EDITOR's NOTE from 1772b-I2C-contrib-bwy-v9-FINAL to this document v10. – DELETE after presentation to IEEE 1722.

9.4.16. I2C message

IEEE P1722b Draft 1.108 Contribution – I2C
IEEE Standard for a Transport Protocol for Time-Sensitive Applications in Bridged Local Area Networks

Figure 79 – I2C Bus and Agent Request: Response Examples

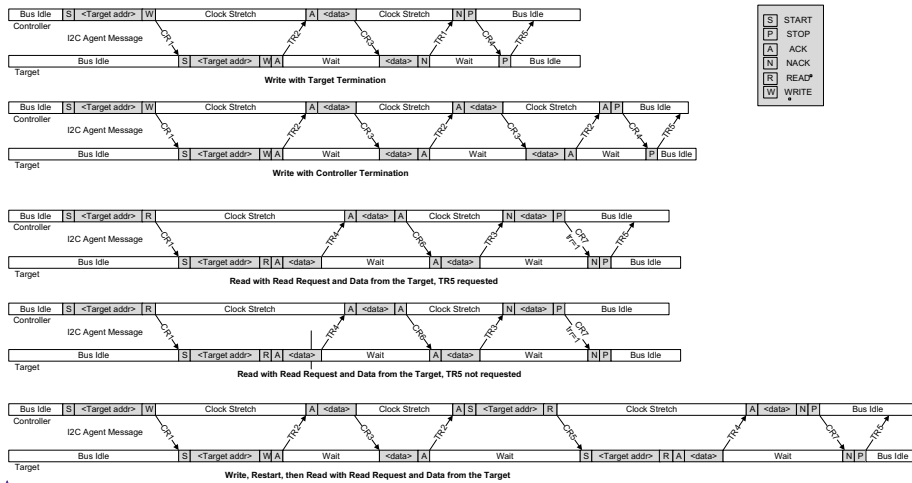
2. Two types of read – read with early (ack) response and read with ack and data response are the controller's choice with no clear benefits for having the two variations. Remove read with early (ack) response to simplify operation.

Consequence: In Table in 9.4.16.19, the variable "RR" is replaced with "1", and references to "early response" operation in text is deleted. And Diagram in the same sub-clause revised.]
